We are submitting this letter in regard to the proposed development of 440 Veteran's Drive & 104 White Crescent. Below are some concerns with the proposed development, and a comment on the label 'Affordable Housing' when applied to freehold properties that include a common element.

Regarding the proposed development 440 Veteran's Drive & 104 White Crescent;

From: eric ellis
Sent: Monday, March 25, 2019 12:31 PM
To: Andrew Gameiro <Andrew.Gameiro@barrie.ca>
Subject: Veterens Dr. 440

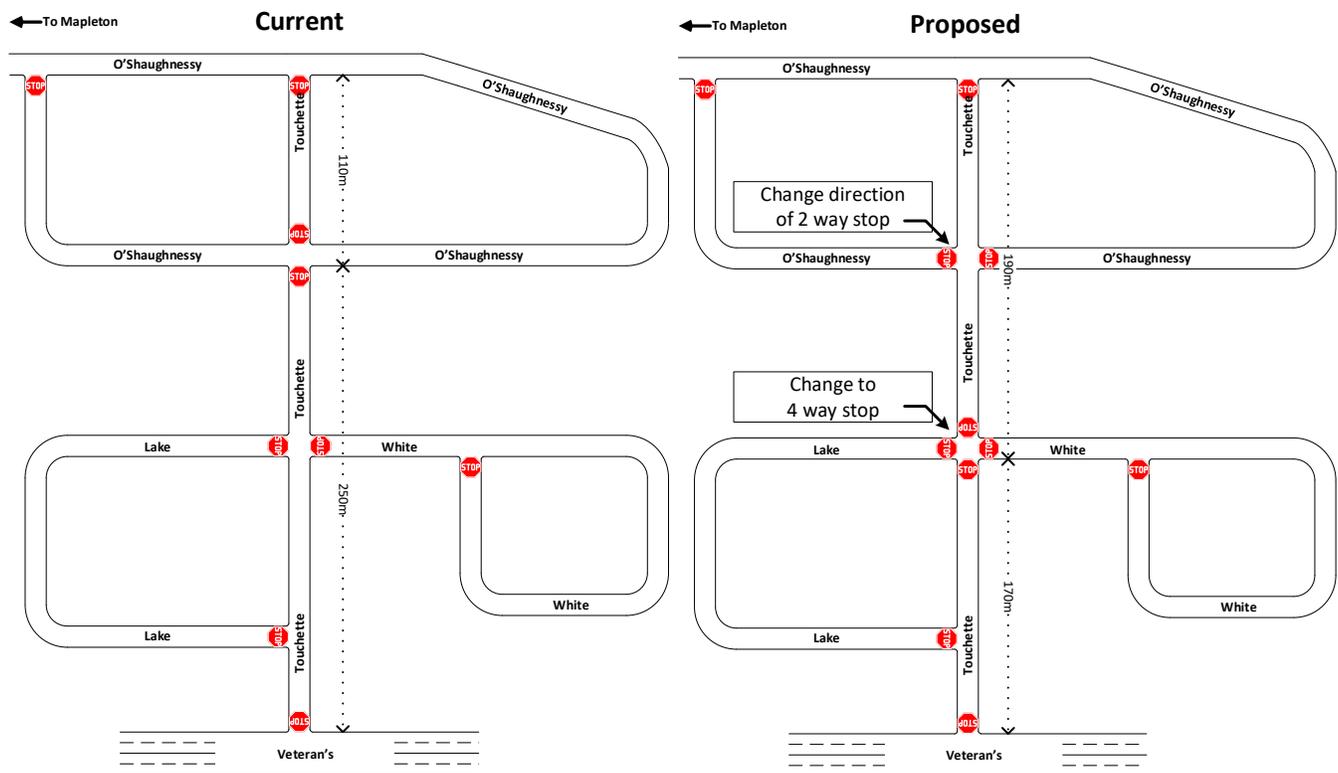
4. **Lighting** - Lighting on the common element portion of the proposed build site has the potential to impact the bedrooms of the properties to the West & South. We request that any night time lighting installed on the common element or the townhomes be properly designed to avoid impact on adjacent properties, even to the extent of shading to prevent intrusion to the bedrooms of adjacent properties.
